ATA Security feature Set Clarifications

To: T13 Technical Committee
From: Jim Hatfield
Seagate Technology
(with Jeff Wolford: Hewlett-Packard)
389 Disc Drive
Longmont, CO 80503
Phone: 720-684-2120
Fax: 720-684-2722
Email: James.C.Hatfield@seagate.com
Date: February 6, 2006

I propose that the following text be incorporated into ATA/ATAPI-8 ACS.

Figure 1 - Security State Mode Diagram

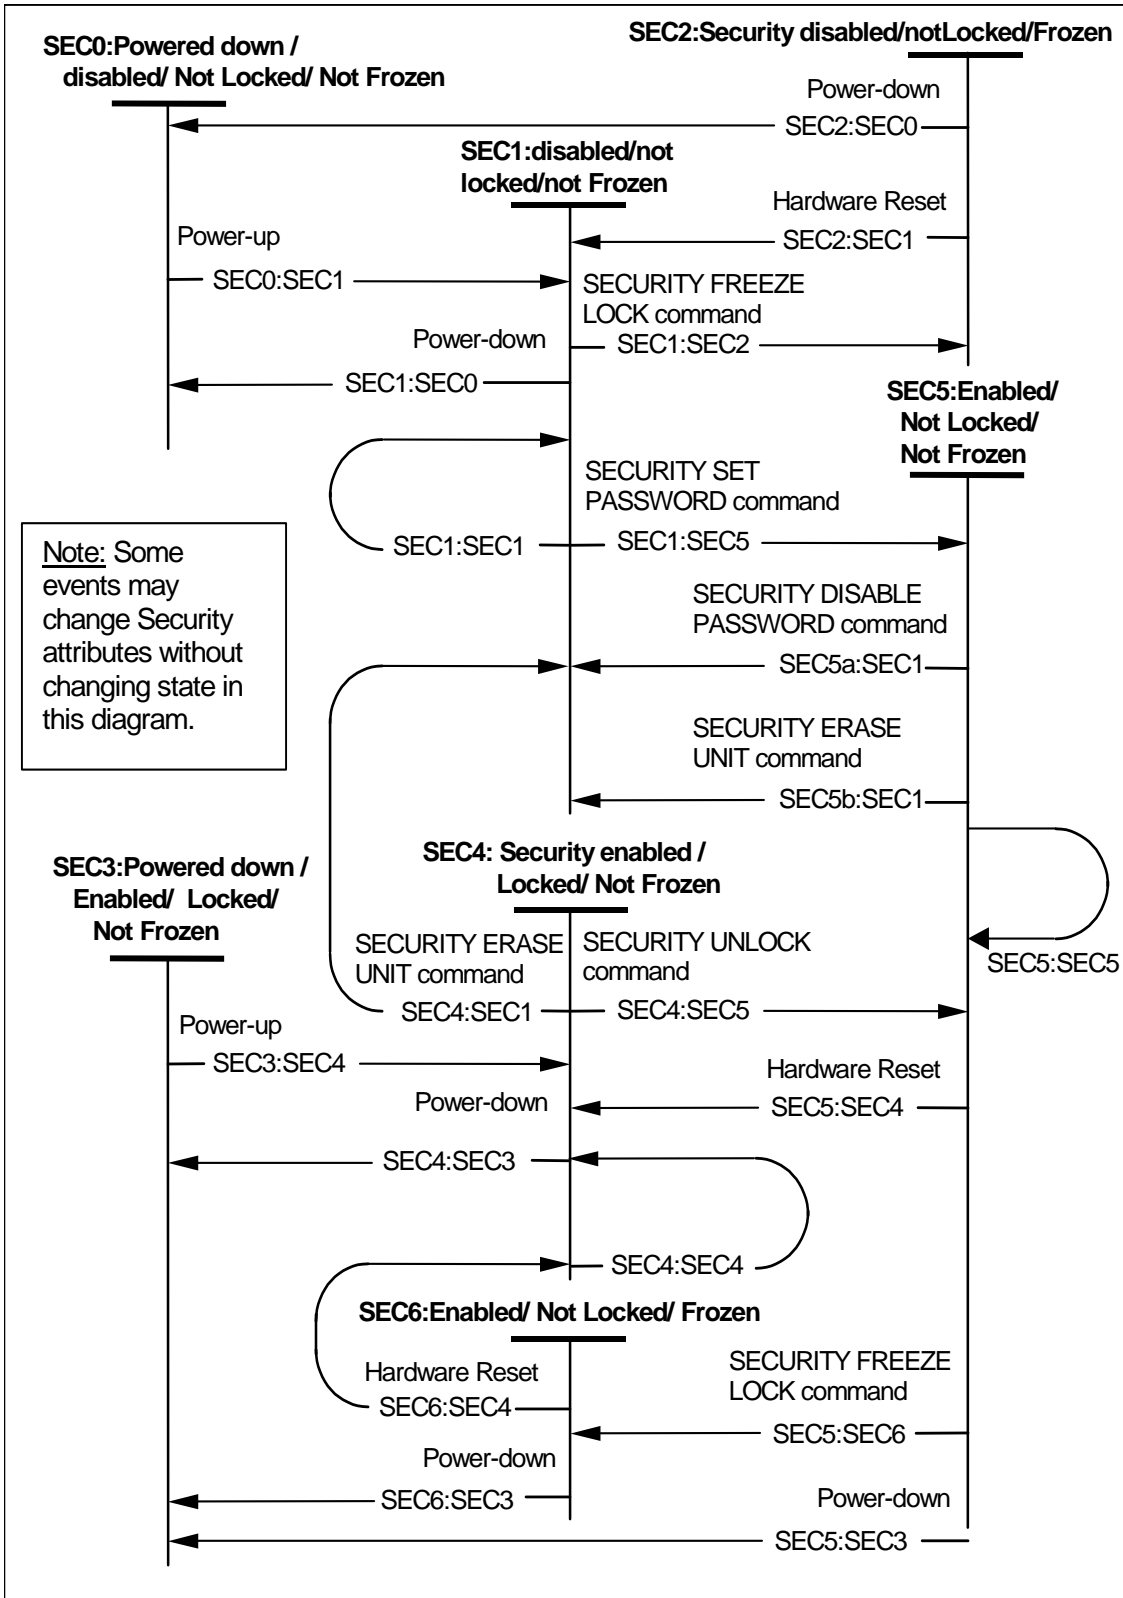
[Editors note: This section conflicts with **Figure 1**, (transitions SEC2:SEC1, and SEC6:SEC4), and with section 1.11) How to resolve it ? The stated precedence is Tables, Figures, and then text. The Figure allows Hardware reset to clear the Freeze Lock, but it is within the text that the conflict exists. So, the text must be made to agree with the Figure.]

Transition SEC2:SEC1: When the device receives a hardware reset, the device shall make a transition to the SEC1: Security disabled/not Frozen state. ~~[Editor's note: Frozen state is only exited after a power-on reset. This is a bug that has persisted and was never discovered before.]~~

Transition SEC6:SEC4: When the device receives a hardware reset, the device shall make a transition to the SEC4: Security enabled/Locked state. ~~[Editor's note: Frozen state is only exited after a power-on reset. This is a bug that has persisted and was never discovered before.]~~
